<p><b>Safety Recall: NHTSA # 25V-145</b>  <b>March 2025</b></p>
---

**IMPORTANT SAFETY RECALL**

## IMPORTANT SAFETY RECALL CAMPAIGN

Occupant and Cargo Carrying Capacity Label

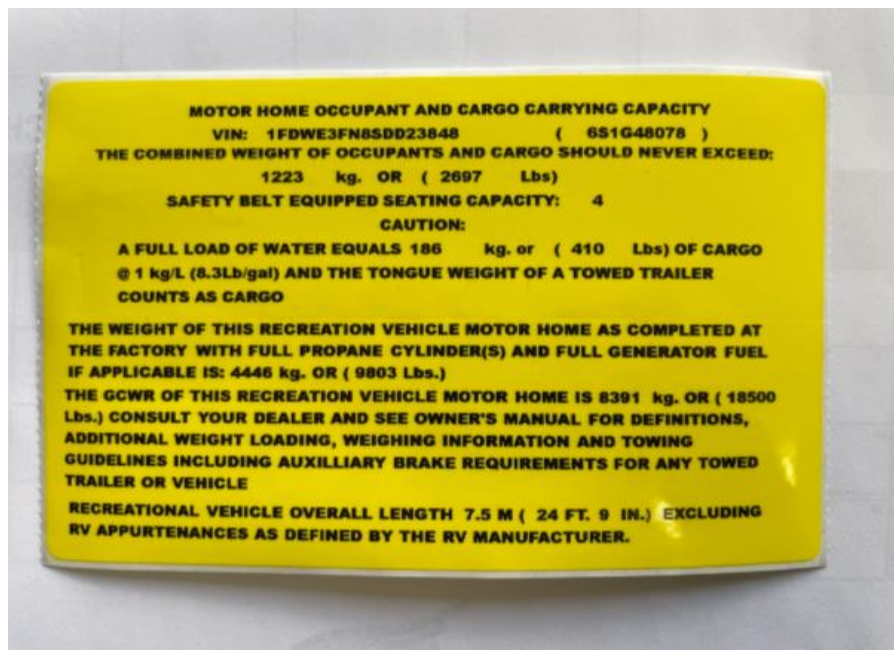
**Reason for this recall**            The weight information listed on the Occupant and Cargo Carrying Capacity (OCCC) label may be incorrect and allow the vehicle to be overloaded. An overloaded vehicle increases the risk of a crash.

*The Occupant and Cargo Carrying Capacity label below is only an example of the label you are to replace.*

**Recall Remedy**                Remove the incorrect Occupant and Cargo Carrying Capacity (OCCC) label and attach the new correct label. The remedy will take approximately 15 minutes to complete. The recall remedy is free of charge.

1. Remove the protective back from the new labels. Align the new labels in the same location of the original labels and apply it to the surface. Remove any air bubbles from the labels.
  - a. Note: Do not attempt to remove or adjust the label once it has touched the surface. Doing so may damage the labels or cause it not to adhere properly to the surface.
